Job Ref: 17013

APP-123602 | 174-176 BROOKVALE ROAD, HASTINGS | RESPONSE TO FURTHER INFORMATION

Armatec Response to Item 1

Extraction Prelim Design

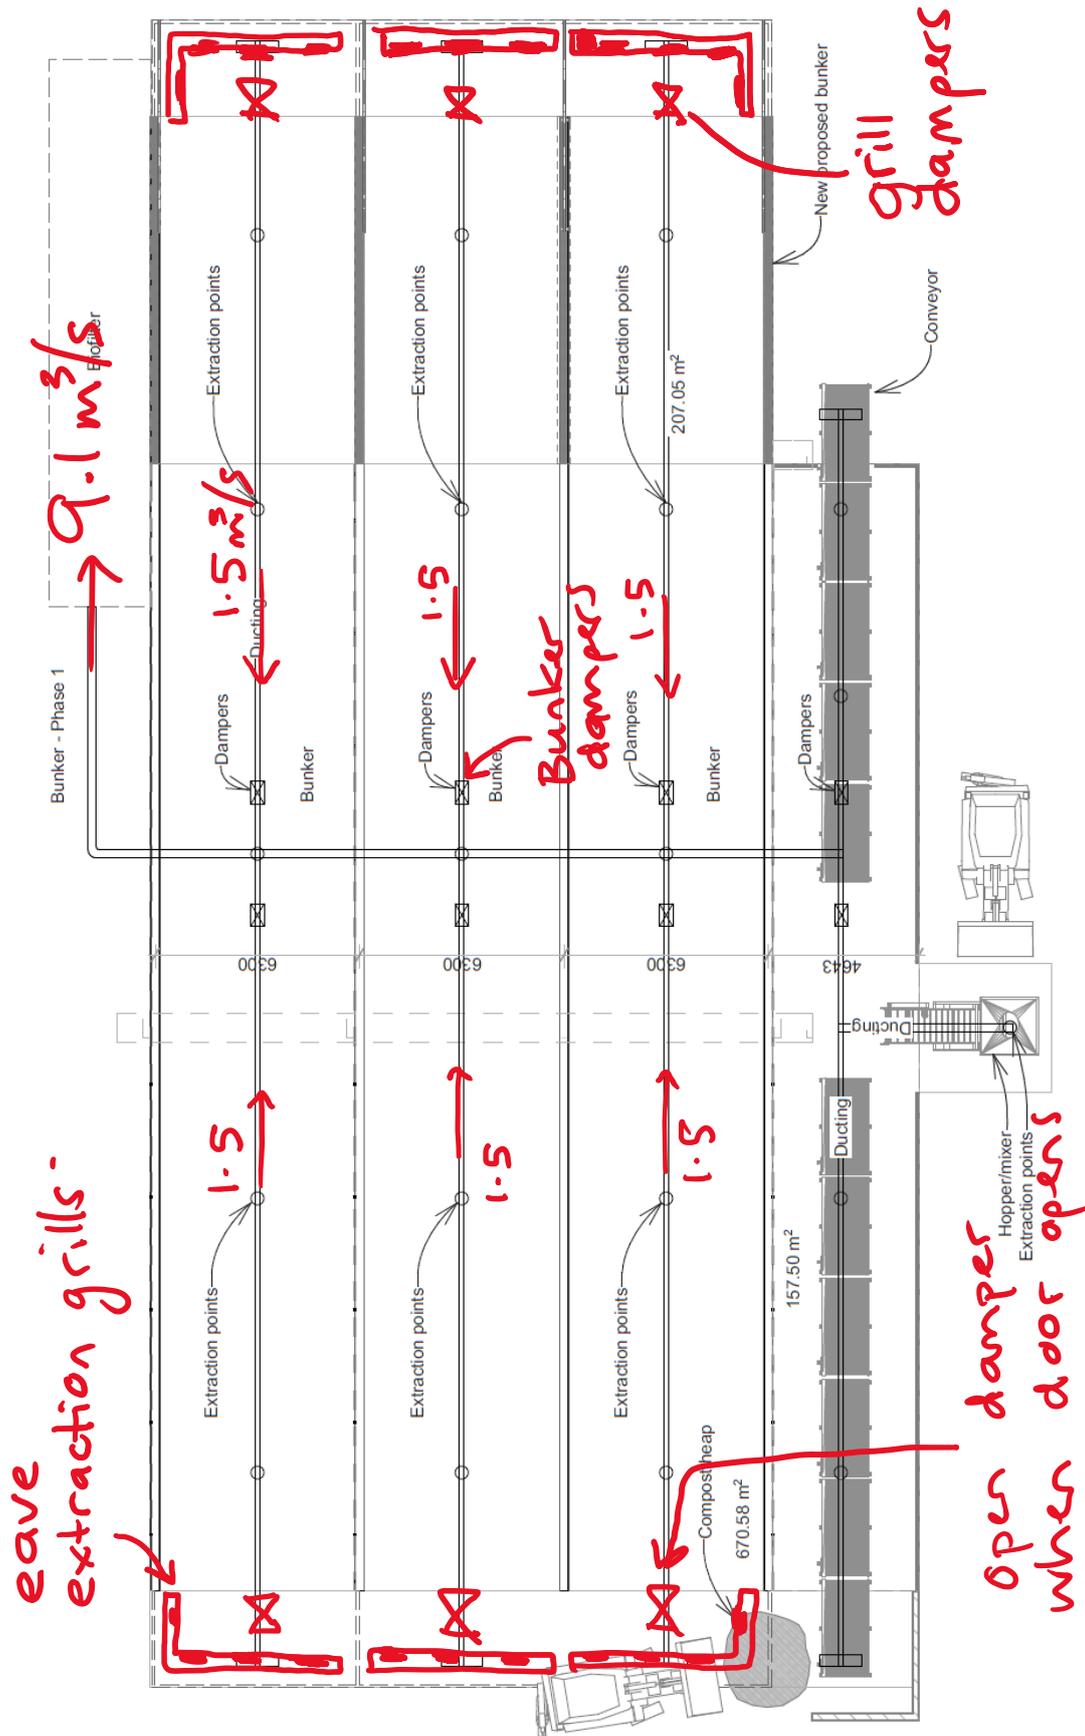
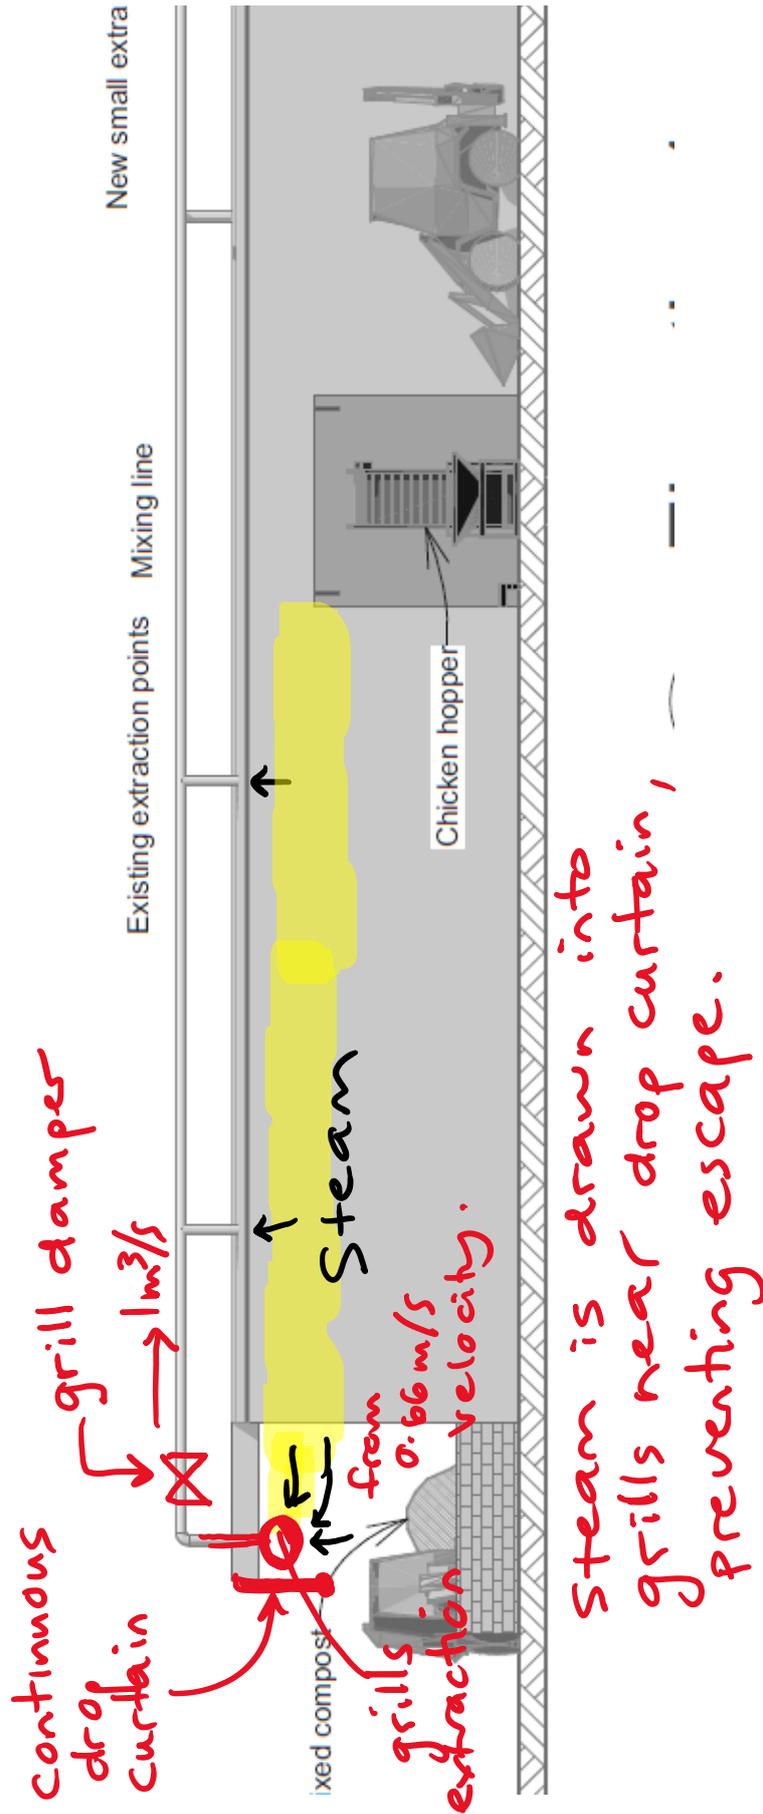
- 1. Our s92 request of 26 January 2017 requested more information on the extraction system for the proposed Phase 1 bunker extended eaves/hoods. We asked for details of the air extraction volumes required to achieve fugitive emission capture rates that will lead to a significant reduction in off-site odour impacts.***

As previously stated in my letter dated 30 August 2017, the Armatec information (provided 5 May 2017) did not fully provide the requested information. The AECOM review (16 May 2017) lists the information that is required, being extraction rates, capture velocities, and exhaust point location/design.

This information is critical for showing that the proposed extended eave and increased extraction can be relied on to reduce fugitive odour. This was recognised by the odour experts in their joint witness statement (21 May 2019), which states (Item 4) that engineering information on the extraction and treatment system and how this proposed system will work should be provided prior to the hearing.

Please provide the information outlined above.

“PROPOSED EXTRACTION LOCATIONS

Currently there is a single, central duct extraction point on the bunkers – drawing air from the centre of the bunkers. This is effective for gas extraction and odour control during times when the doors are closed, but suboptimal during times when the doors are open. Therefore adjustments are planned for.

The planned extraction design is to have:

- a. More extraction points along the ceiling of the bunker(s) for more equalised removal along the bunkers
- b. Extraction points along the width of the bunker eave behind the curtain to optimise the extraction of the built-up hot gases during the times that the doors are open.
- c. Increased controls on extraction rates at the provided points to better direct/prioritise the total extraction airflow to maximise gas capture prior to escape. For example, when a door is open, then controls will be adjusted so the maximum possible extraction rate is achieved in those bunkers near the openings to minimise gas escape."

Duct extraction design is done in a way to enable appropriate extraction control. Therefore dampers play their part in appropriate balancing of the overall design following implementation.

The following page provides the design concept of the extraction positions around the bunkers and the door eaves. Grills will be on the extraction ducting around the complete perimeter of the eaves and drop curtains. This will give added protection when the doors are open. The grills will be on approx 500NB duct, with adjustable grills built in.

When the doors are closed, the grills will not be in operation. When a bunker is not in operation the bunker damper will be shut off, allowing additional airflow to come from other bunkers.

When the doors are open, per bunker, the "grill damper" controlling extraction from that grill will open, allowing air to be extracted from that point. The extraction rate will be up to $1\text{ m}^3/\text{s}$ per bunker (with the remaining $0.5\text{ m}^3/\text{s}$ being extracted from the rest of the bunker. The middle bunker has a 6m eave length. Therefore at 500mm height, over 3m, this is a 1.5 m^2 area, and this will pull at a rate of $1\text{ m}^3/\text{s}$ and 0.66 m/s velocity, although that could be increased up to 10 m/s depending on the grill opening position.
